# CITY PLAN COMMISSION STAFF REPORT

## Project Name KC Outlook

.1 - CD-CPC-2019-00055 - Rezoning with Plan.  
.2 - CD-CPC-2019-00065 – PIEA General Development Plan.

## Plan Conditions, Corrections, & Recommendations Report

**1 DEVELOPMENT SITE PLAN**  
SCALE: 1"=30'-0"

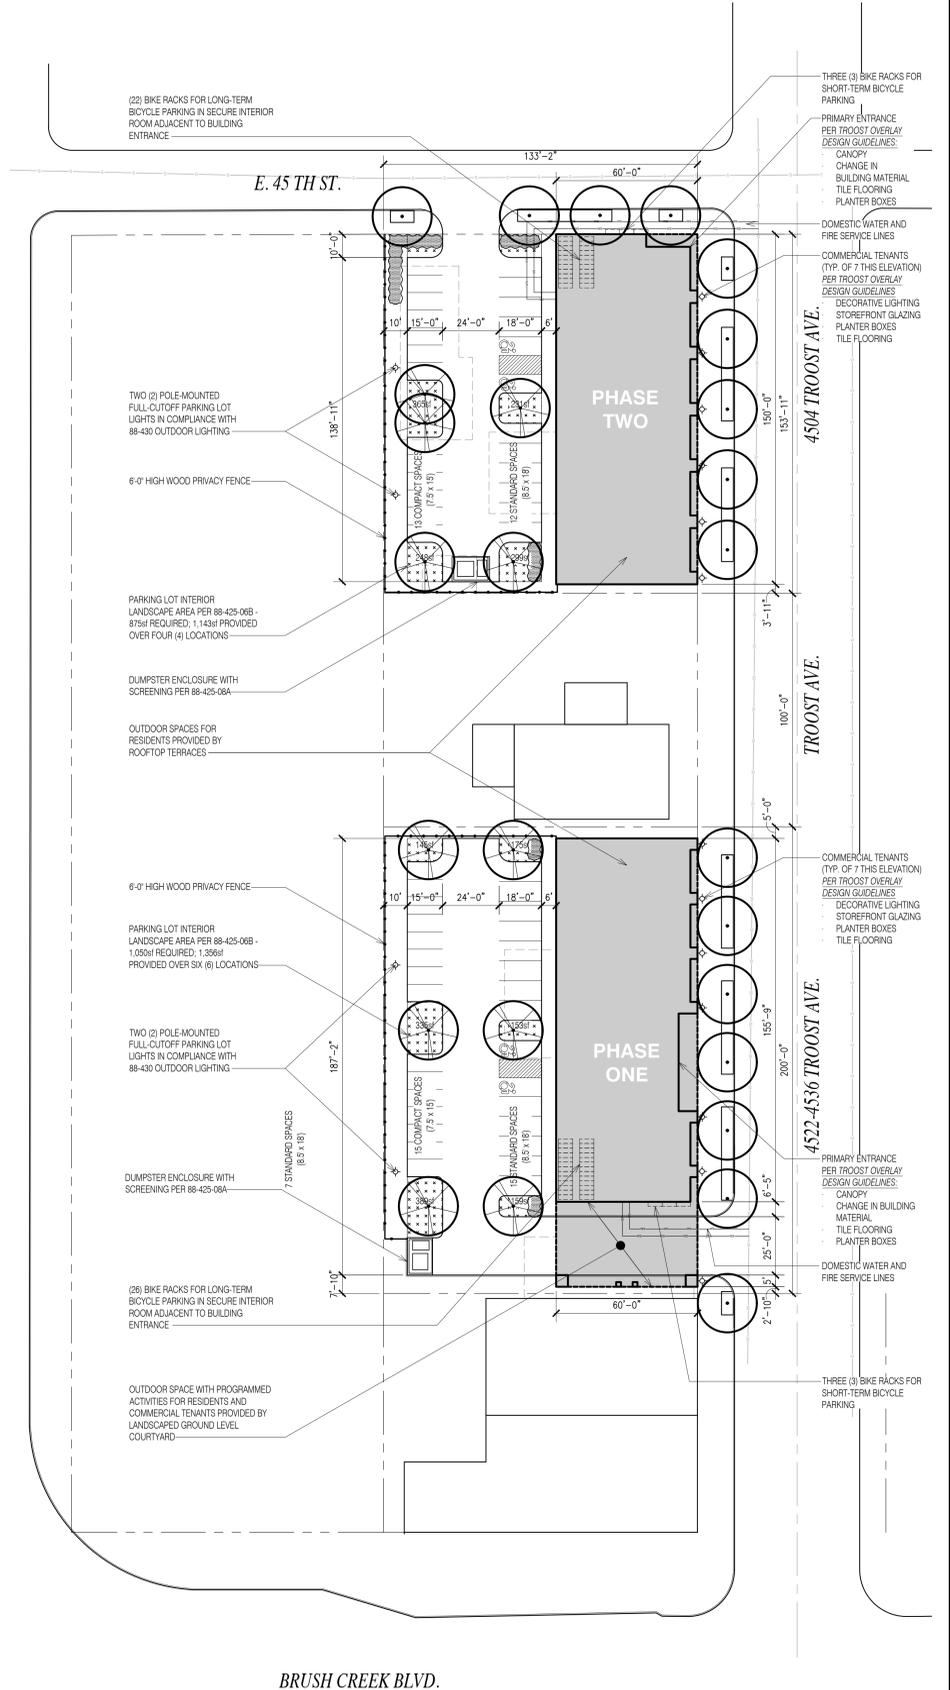
1. Provide an outdoor lighting plan conforming to 88-430. Revise Plans and Resubmit (4/14/2020)
2. Per the Troost Overlay, maximum building frontages on Troost is 150'; the southern building exceeds this maximum. A variance, reviewed by the Board of Zoning Adjustments, would be required to exceed this maximum. Separate variance application must be filed on CompassKC. Revise Plans and Resubmit (5/20/2020)
3. Provide detail on pedestrian crossing safety measures for crossing of parking entrance.

Include crosswalk demarkation including raised/stamped/colored concrete, use of other material, or the like to provide clear safe passage across. Revise Plans and Resubmit (5/20/2020)

4. Collate and bind all plan set into one and resubmit. Revise Plans and Resubmit (3/11/2021)
5. Show parking required and parking provided per 88-420 on the face of the plan. If waivers or deviation is been requested, it must be requested. Revise Plans and Resubmit (3/11/2021)

7. Show all chronological plan revision dates on the face of each plan sheet or the plan cover sheet. Revise Plans and Resubmit (8/13/2021)
8. Call out any request for waiver or deviation on the face of the plan. The south building still exceeds the 150' maximum building width. Revise Plans and Resubmit (8/13/2021)

9. Update the parking calculation to show the narrative provided with the revised plan on the face of the plan. Revise Plans and Resubmit (8/13/2021)
10. Clearly depict all POS tracts and amenities to be dedicated in lieu of parkland. Revise Plans and Resubmit (8/13/2021)
